State of New Mexico
 Energy, Minerals and Natural Resources

WELL API NO. 30-025-33202
5. Indicate Type of Lease STATE <input checked="" type="checkbox"/> FEE <input type="checkbox"/>
6. State Oil & Gas Lease No.
7. Lease Name or Unit Agreement Name Hardy 36 State
8. Well Number 19
9. OGRID Number 331199
10. Pool name or Wildcat [29710] HARDY; BLINEBRY
4. Well Location Unit Letter <u>H</u> : <u>1950</u> feet from the <u>North</u> line and <u>330</u> feet from the <u>East</u> line Section <u>36</u> <u>20S</u> Township <u>Range 37E</u> <u>NMPM</u> County
11. Elevation (Show whether DR, RKB, RT, GR, etc.) 3502

SUNDRY NOTICES AND REPORTS ON WELLS (DO NOT USE THIS FORM FOR PROPOSALS TO DRILL OR TO DEEPEN OR PLUG BACK TO A DIFFERENT RESERVOIR. USE "APPLICATION FOR PERMIT" (FORM C-101) FOR SUCH PROPOSALS.)	
1. Type of Well: Oil Well <input checked="" type="checkbox"/> Gas Well <input type="checkbox"/> Other	
2. Name of Operator Maverick Permian LLC	
3. Address of Operator 1000 Main Street Ste 2900 Houston, TX 77002	
4. Well Location Unit Letter <u>H</u> : <u>1950</u> feet from the <u>North</u> line and <u>330</u> feet from the <u>East</u> line Section <u>36</u> <u>20S</u> Township <u>Ran

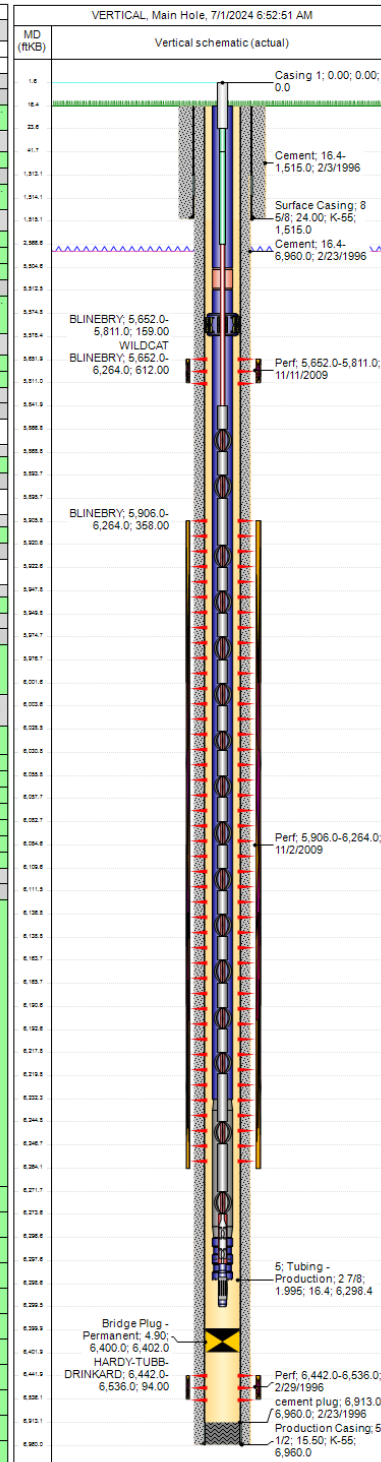
LPC Area Below ground marker send pics before backfilling hole

Top fill production casing with cement.
